## REQUEST FOR INFORMATION

Project Name:	<u>6 Bears &amp; A Goat</u>	R.F.I. Number:	<u>004</u>
Project No:	<u>16136</u>	From:	<u>Corinna Grogan</u>
To:	<u>Stacey Lampman</u>	Date:	<u>7-14-16</u>
	<u>Kelly Penick</u>	Requested Return Date:	<u>7-18-16</u>
Re:		Contract For:	<u>6 Bears &amp; a Goat</u>

# Z806-HDG

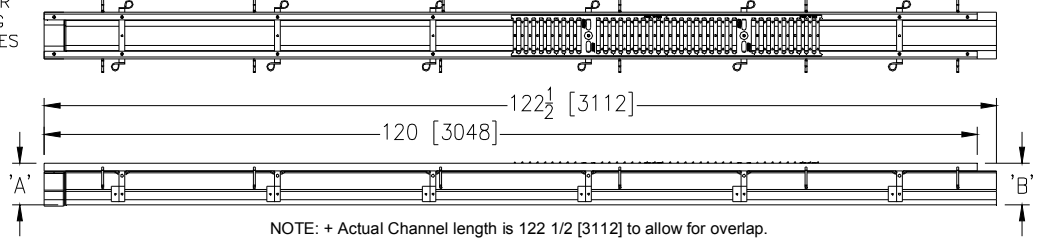
14. Please provide manufacturer, specifications and dimensions for brewery for drains. It is critical that they be ordered as soon as possible for placement and slab prep/pour.

14. Please provide manufacturer, specifications and dimensions for brewery for drains. It is critical that they be ordered as soon as possible for placement and slab prep/pour.

**ZURN, ZV-806-HDG-BDE OR SIMILAR. DID NOT SPECIFY OUTLET ADAPTERS. SEE ATTACHED**
